Botley West Solar Farm

Change Request 2: Consultation Report

PINS Ref: EN010147

Document Ref: EN010147/APP/16.4

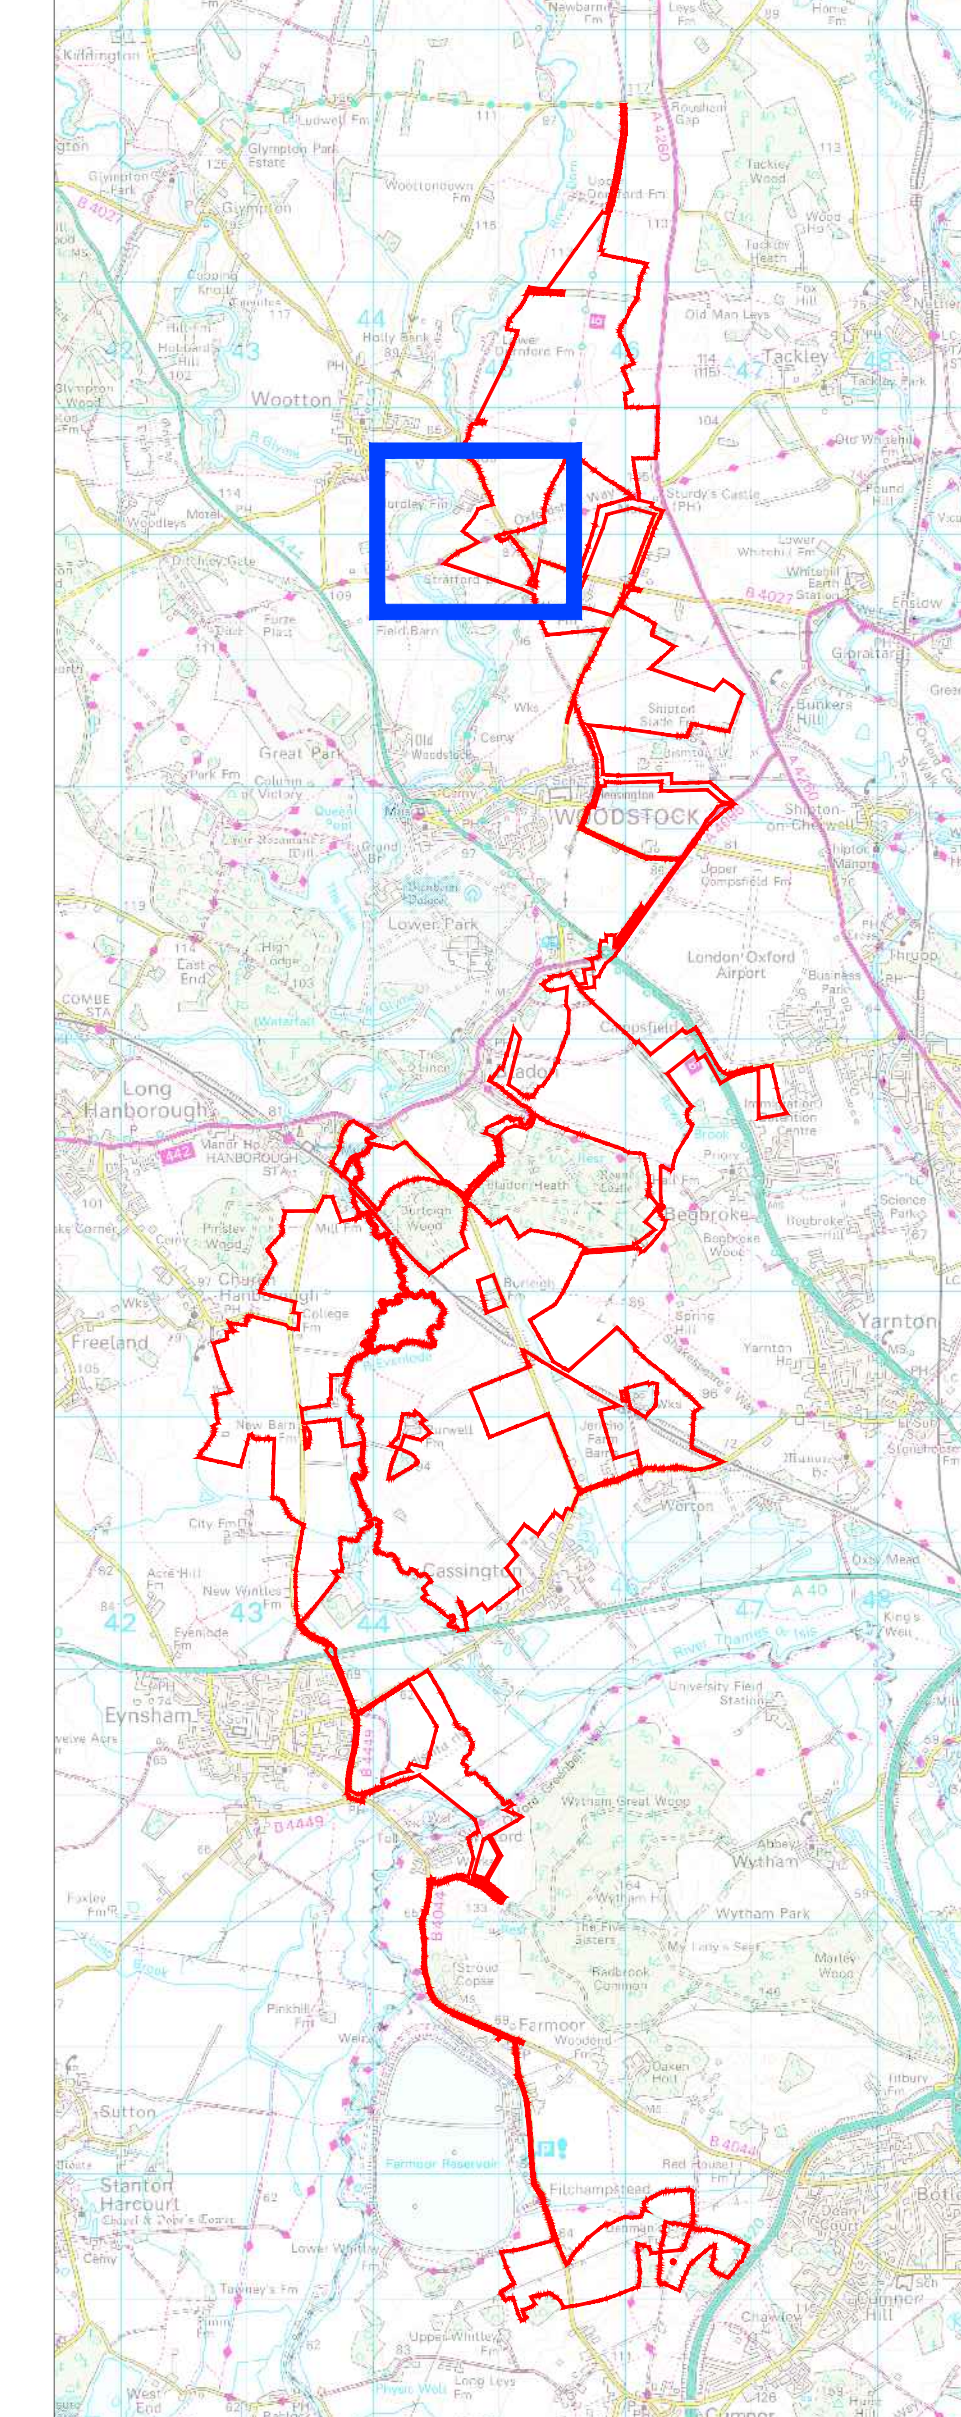
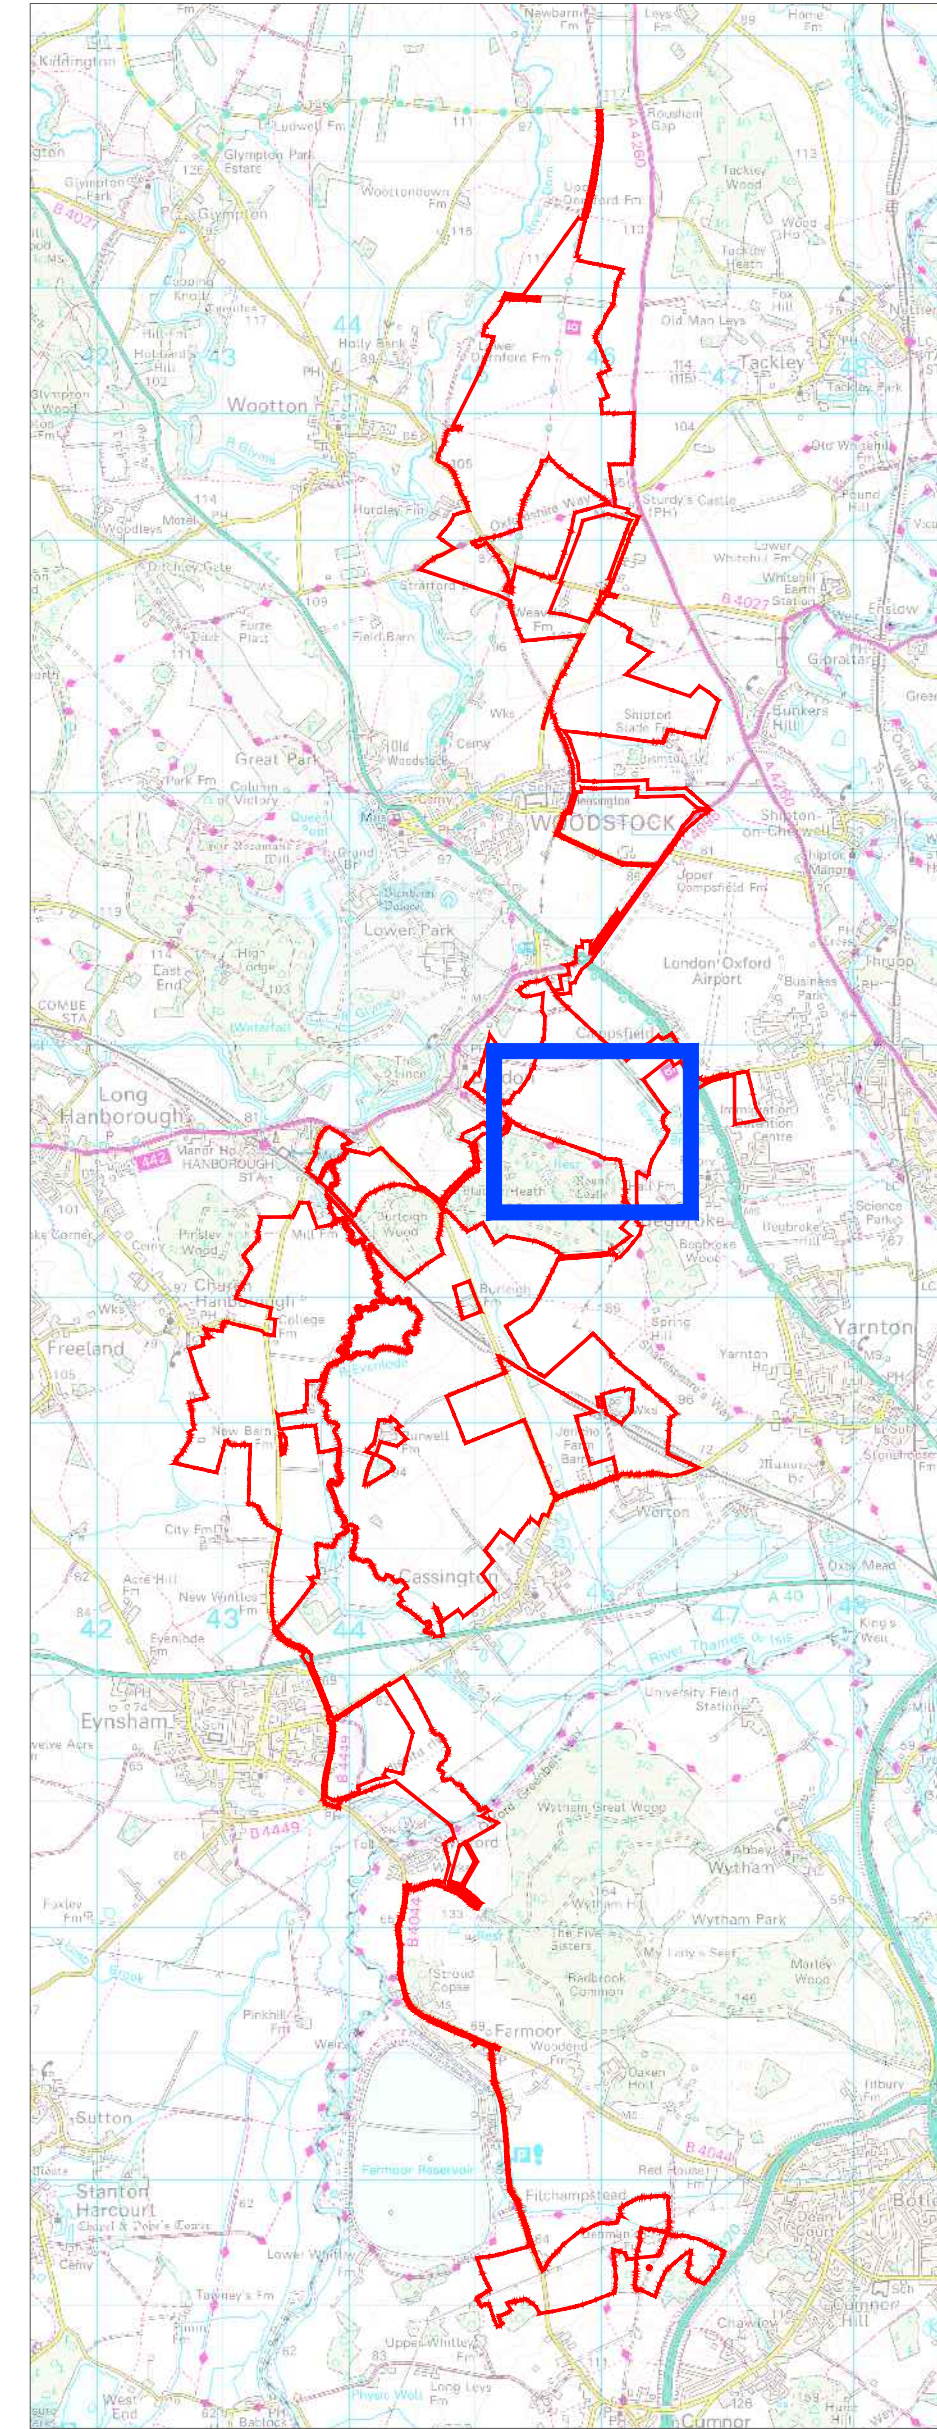
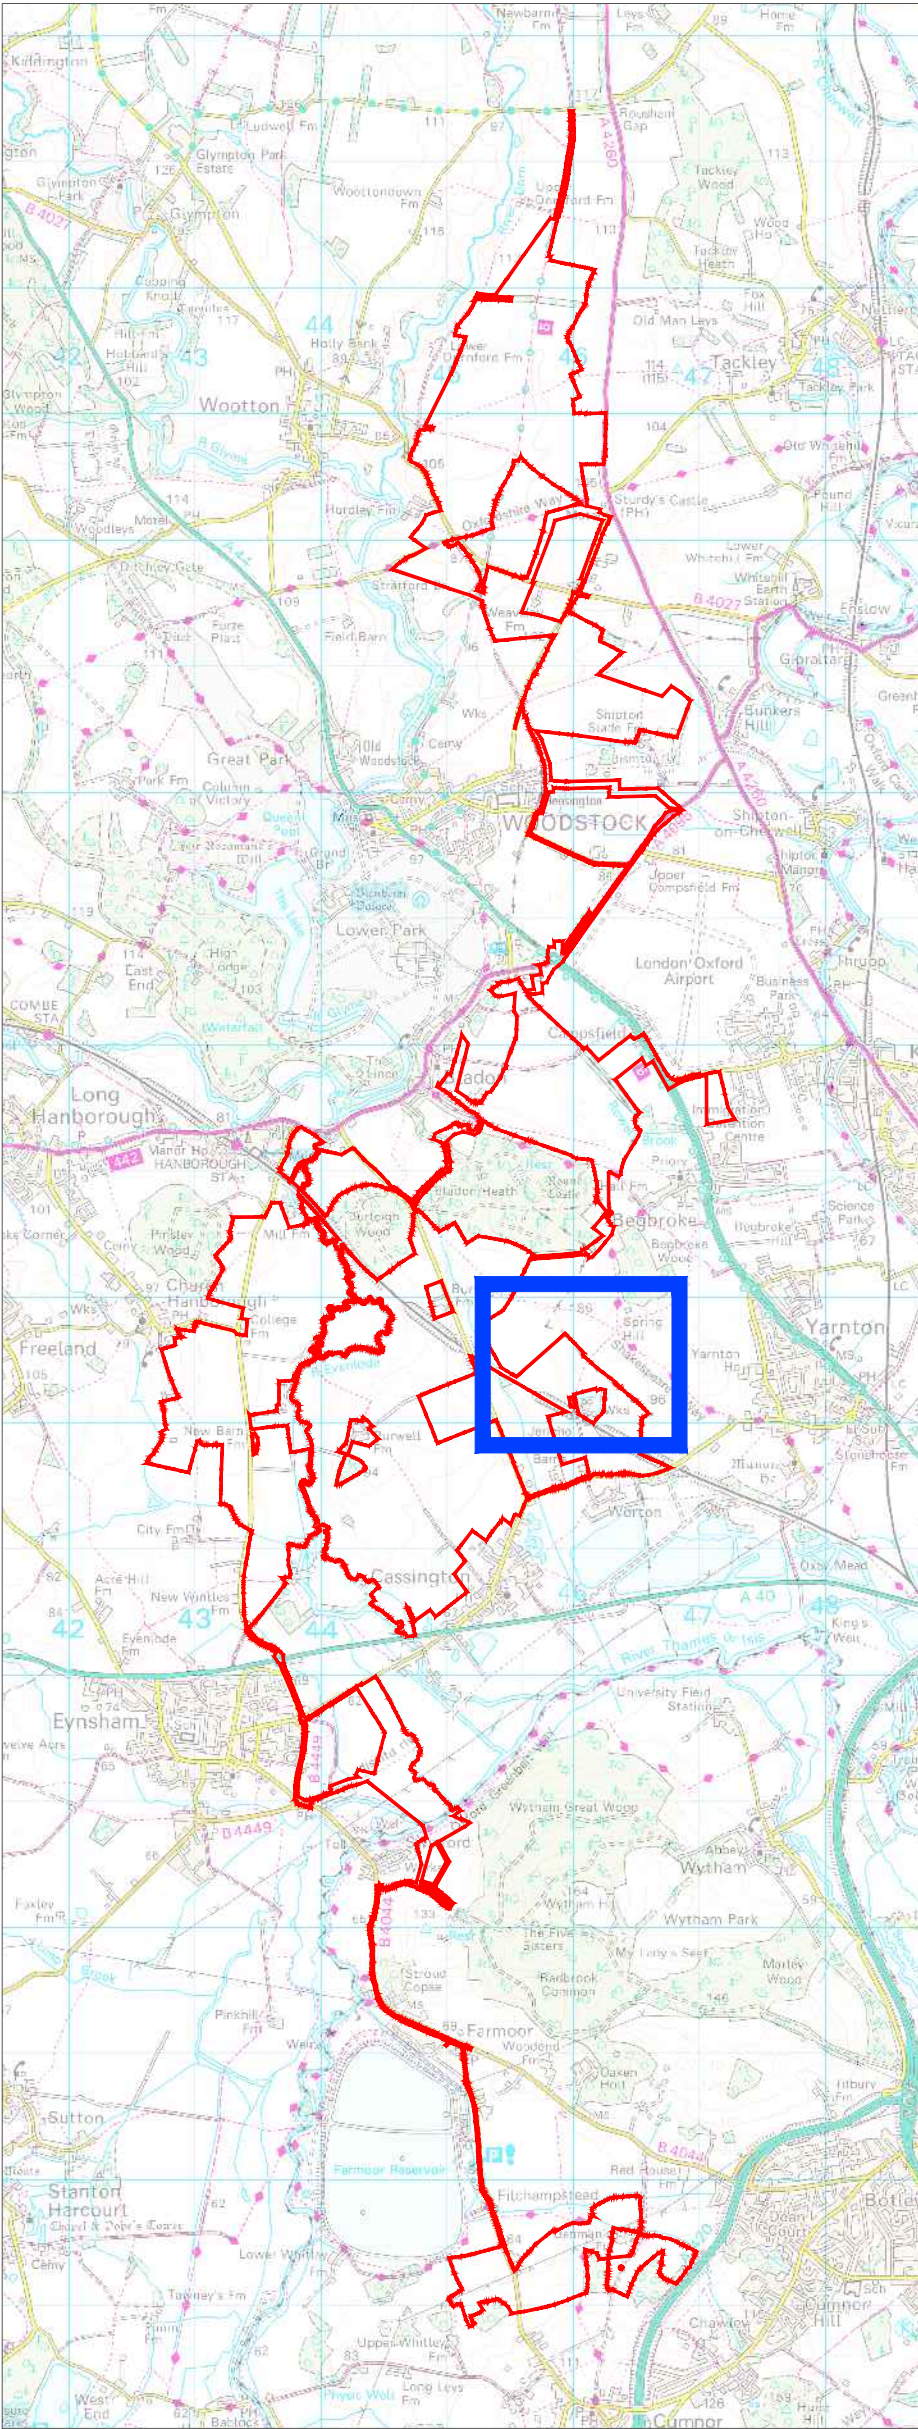
Change 8: Refinement of Project layout and design to reposition the Public Rights of Way currently proposed to be stopped up and diverted back to definitive alignment - (see Appendix A attached to the Notification)

Prior to submission of the Applicant's DCO Application, the Applicant became aware that there was a difference between the aerial data showing the used footpath routes on the ground and the Oxfordshire County Council (OCC) definitive data set of their alignment. The data showed that the routes used by the public deviated from the definitive data set alignment. The Applicant therefore sought powers to alter the alignment of the PRoW to reflect the 'desire lines' on the ground. However, following ongoing discussions with OCC, the Applicant is seeking to remove those powers to adopt the OCC definitive alignments which will result in a change to the submitted plans.

Title Change Request 2 Notification - Change 9

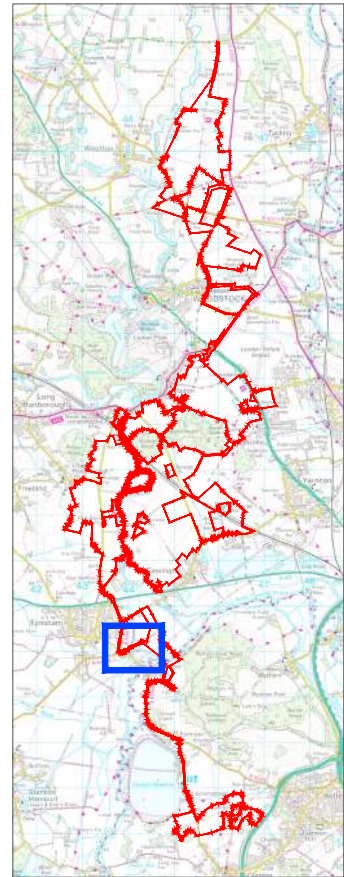
Change 9: Reduction in Order Limits boundary to remove an area of land along Wharf Road

This change will result in alterations to the Order Limits and a reduction in the area of land included within the Order Limits. The precise extent of the change will be discussed with Siemens and once settled form part of the formal Change Request. A suitable plan will be produced at that stage to confirm the extent of the change. The change will not result in any new land interests, as no new land is sought to be brought into the Order Limits, and no likely new or different significant environmental effects are anticipated as a result of this change.
